Oxley Creek Transformation Project

Graceville Riverside Parklands

Draft Precinct Plan

Community Engagement Summary Report

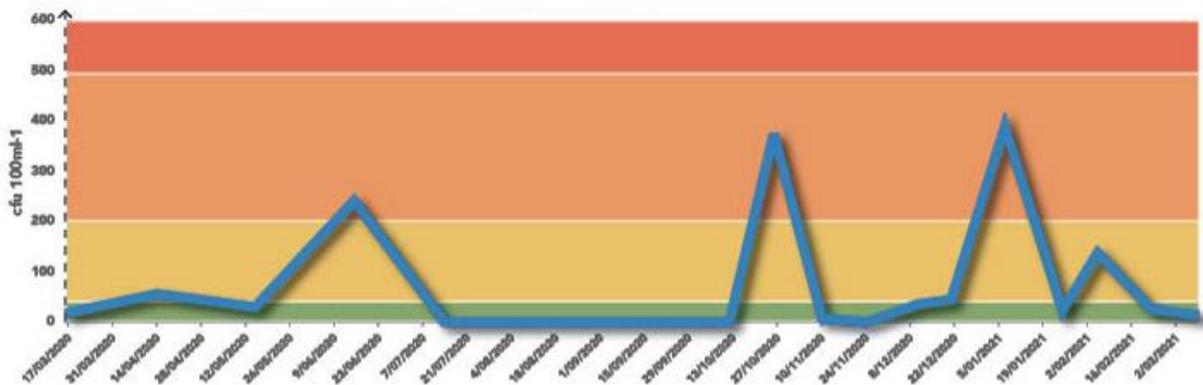
Community feedback reinforced the need to retain as much open greenspace as possible within the parklands, as well as a preference to use active transport options to access the parklands for picnicking and play. To this end, the Junior Greenway looped scooter track has been reimagined as a series of short obstacle detour features that will be spaced out parallel to the existing pathways within the parklands. Each detour will feature one or more challenging obstacles for scooter users to negotiate. The space previously ear marked for the scooter track has been identified for picnicking and informal use.

The size of the Water Activity Hub rigging area has also been reduced to limit the amount of new hardstand.

The additional hardstand paths proposed within the Concept Plan are proposed to remain to provide improved accessibility for all users of the parklands.
